AIA® Document A133™ – 2009 Exhibit A

Guaranteed Maximum Price Amendment

DVUSD Arrowhead E.S. Modernization
7490 West Union Hills
Glendale, Arizona 85308

Exhibit A.1 - GMP Summary Sheet

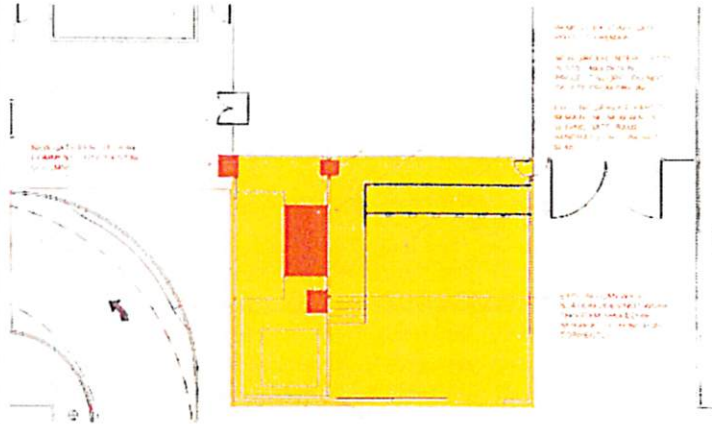
- Grass areas north of Building 200 and west of Building 300 will remain.

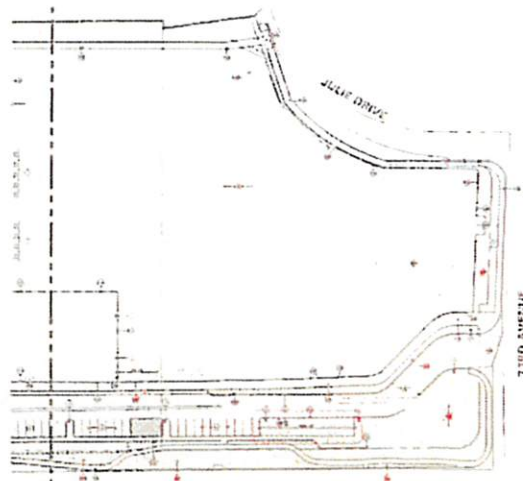
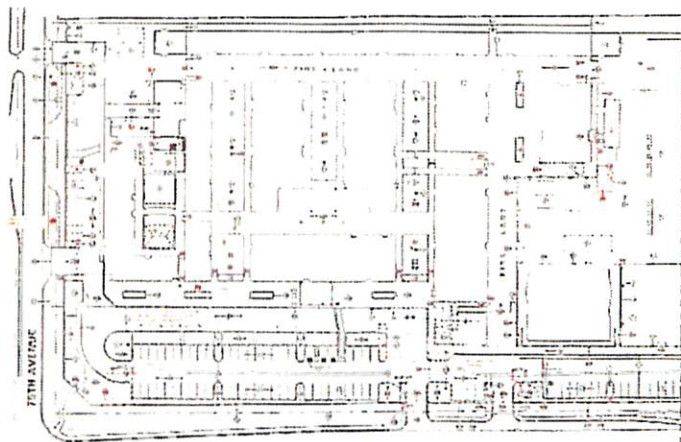
- o Concrete paving, walls, and sliding gate at the Service Yard will remain. The existing grease interceptor with associated concrete flatwork, and existing man gates adjacent to Building 800 will still be removed.

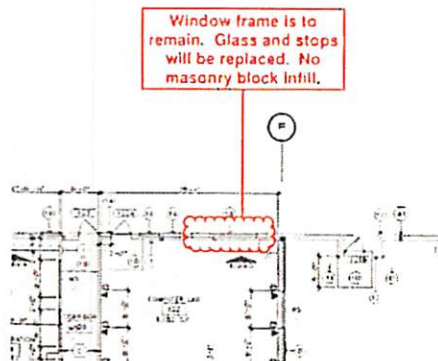
- o Existing concrete pavement 5' wide south of Buildings 400 and 900 will be removed for new secondary electrical feeders.

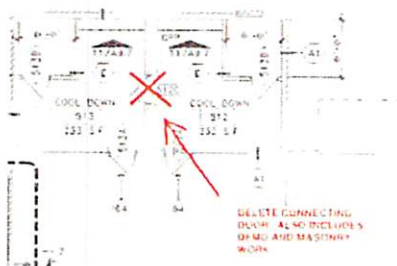
- At Building 800, the east elevation masonry walls will not include cut-outs for new hollow metal clerestory windows. The Stage walls and platform will remain as-is.
- At Building 500, Boys 501 and Men 502 Restrooms, hollow metal doors, frames, and hardware 501A1 and 501A2 will be removed. All other scope will remain as-is and will not be removed.
- At Building 600, Women 614 and Girls 615 Restrooms, hollow metal doors, frames, and hardware 615A1 and 615A2 will be removed. All other scope will remain as-is and will not be removed.
- At Building 700, Girls 710, Staff Women 711, Staff Men 712, and Boys 713 Restrooms, all scope will remain.
- At Building 400, existing Door 401B hinges, frame, and doors will remain as-is. All other hardware will be removed.
- At Building 500, new Door 512C between Cool-Down Rooms 512 and 513 will not be required so masonry block will not be removed.

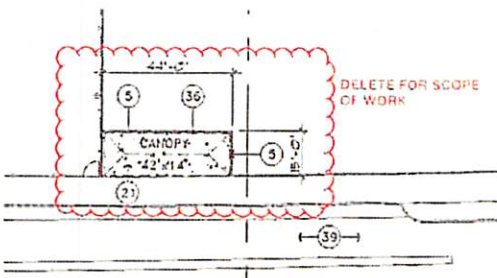
- Raised planter at southwest corner of Building 100 will remain and not removed for a new shade canopy.

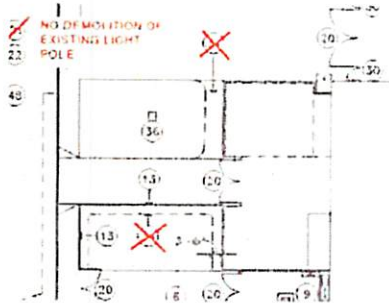
- Chain link fence east of the basketball courts will not be removed for a new shade canopy.

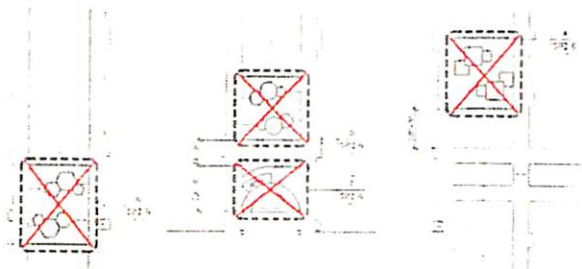
- o Grass areas north of Building 200 and west of Building 300 will remain. Irrigation modification and new concrete mow curb are not included.

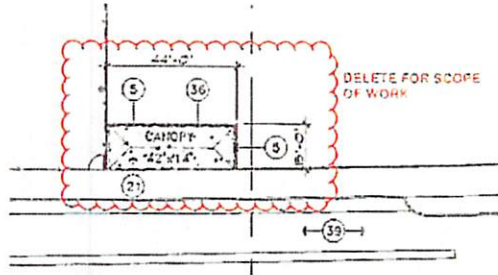
- o Concrete light pole bases are not included. Existing light poles will remain as-is.

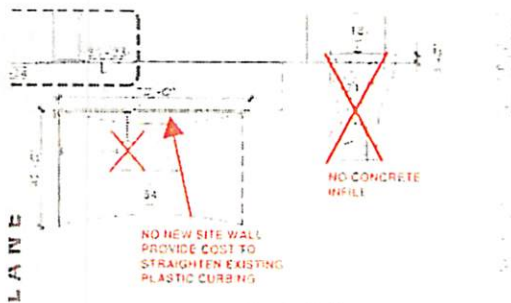
- o The new shade canopy east of the basketball courts will not be included. Concrete pad and footings are not required.

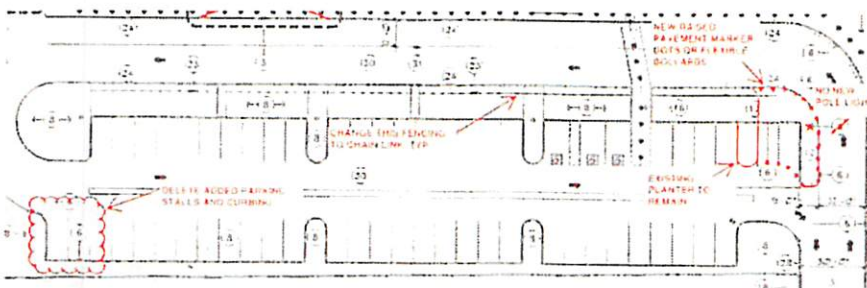
- o Concrete footings for the site wall east of Building 1000 at the playground are not included.
- o Concrete sidewalk infill at the southeast corner of Building 800 is not included.

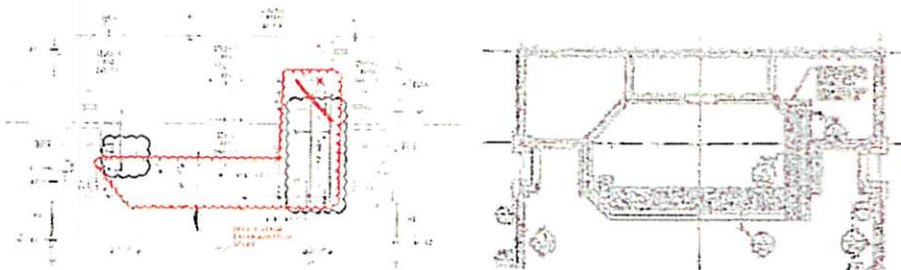
- o Concrete curb divider at the west parking lot and drive along 75th Avenue has been removed. In addition, the new straight curb has been moved to the east to encapsulate the existing concrete light pole bases.

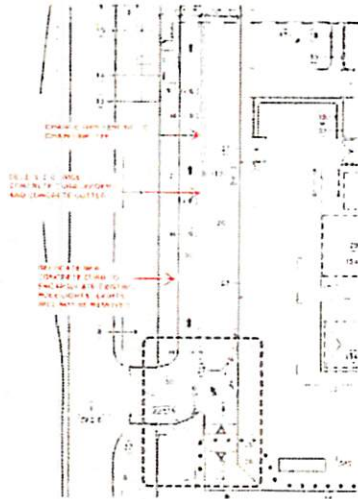
- o At Building 500, Boys 501 and Men 502 Restrooms, existing masonry wall partitions and plumbing fixtures will not be removed. As a result, slab-on-grade will not be replaced.
- o At Building 600, Women 614 and Girls 615 Restrooms, existing masonry wall partitions and plumbing fixtures will not be removed. As a result, slab-on-grade will not be replaced.

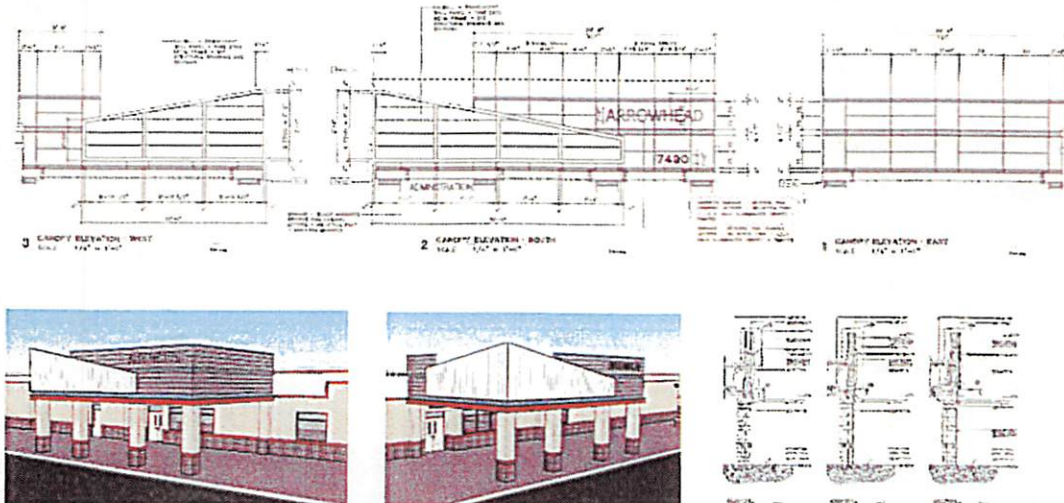
- At Building 100, the existing entry canopy façade enhancements have been reduced. The structural steel framing for the translucent wall panels has been removed. Only a bottom support channel remains.

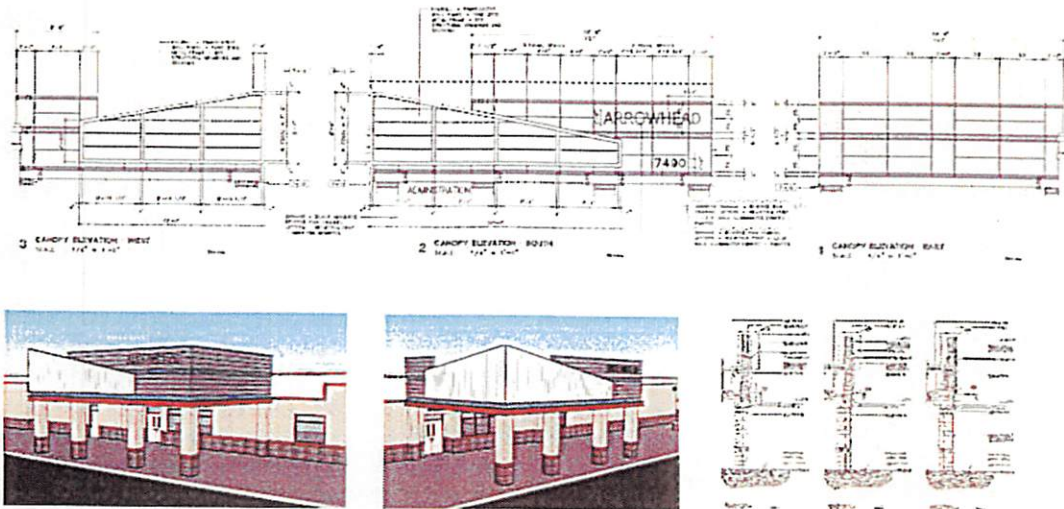
- At Building 100, the existing entry canopy façade enhancements have been reduced. The original design included ACM wall panels which have been changed to MBCI Flexloc 9 1/2" wide panels with flush seams.

Where light gray vertical wall panels are now indicated, the original GMP design had tube steel framing and translucent wall panels which have been deleted.

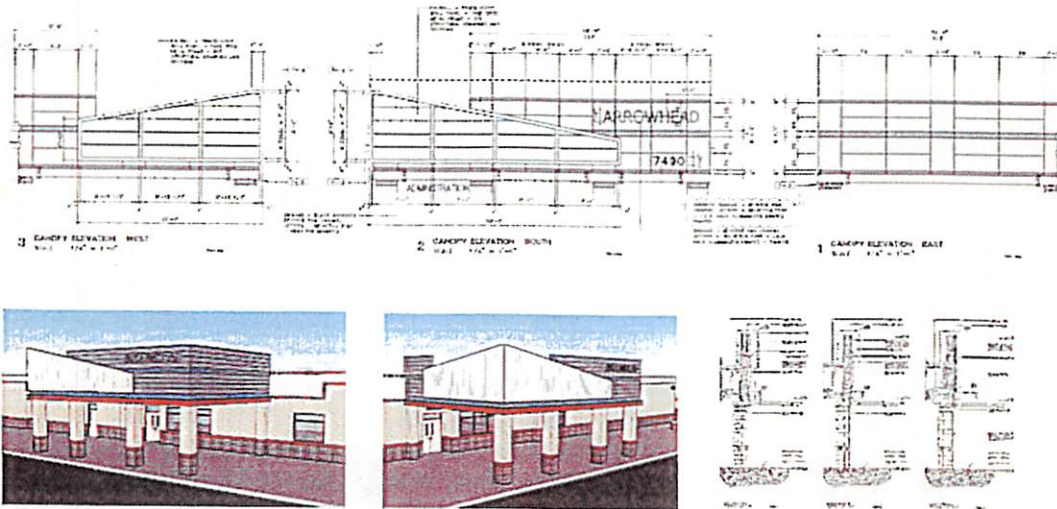
At Building 100, the existing entry canopy façade enhancements have been reduced. The original design included ACM wall panels which have been changed to MBCI Flexloc 9 ½" wide panels with flush seams. Metal panel wraps at the columns are deleted and will now be painted block. Where light gray vertical metal wall panels are indicated, metal stud support is now required. Previously, these areas comprised

painted tube steel framing and translucent wall panels.

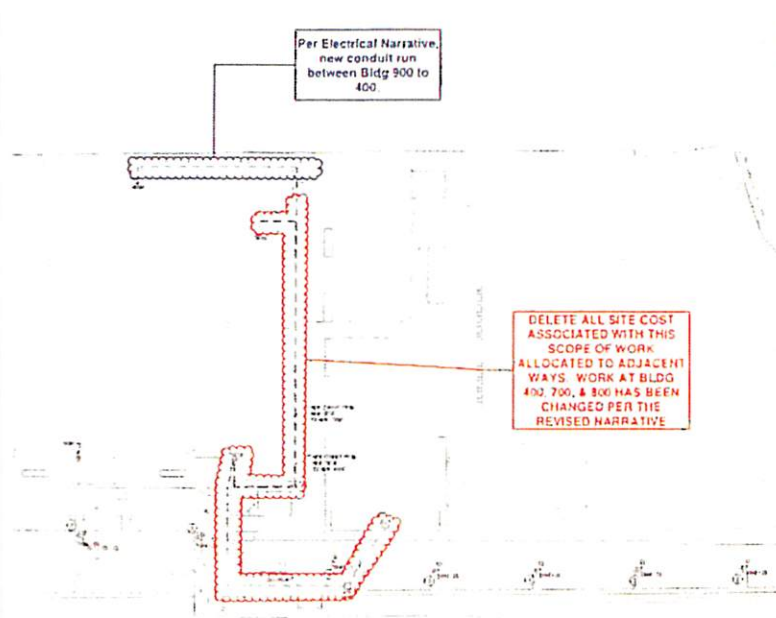
- With the above design recommendations and overall electrical demand load reductions, the current new electrical service feed from the transformer south of Building 1100 to Building 800, new SES8, and secondary feeds to Buildings 400 & 700 has been changed as follows:

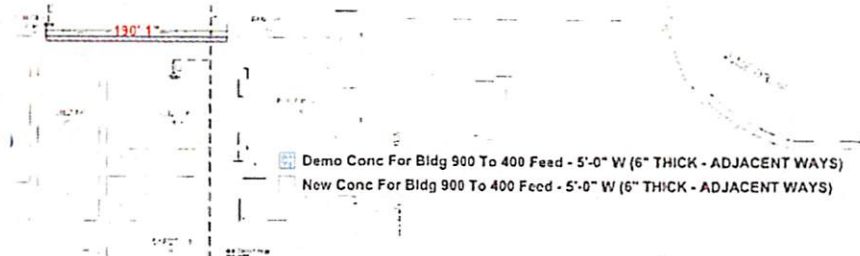
- The Electrical Engineer indicated the new electrical feed between Buildings 400 and 900 along the north elevation. To capture this work in Adjacent Ways, the routing was moved to the South

elevation which will include demolition and patch concrete Fire Lane, electrical conduit, and electrical conductors.
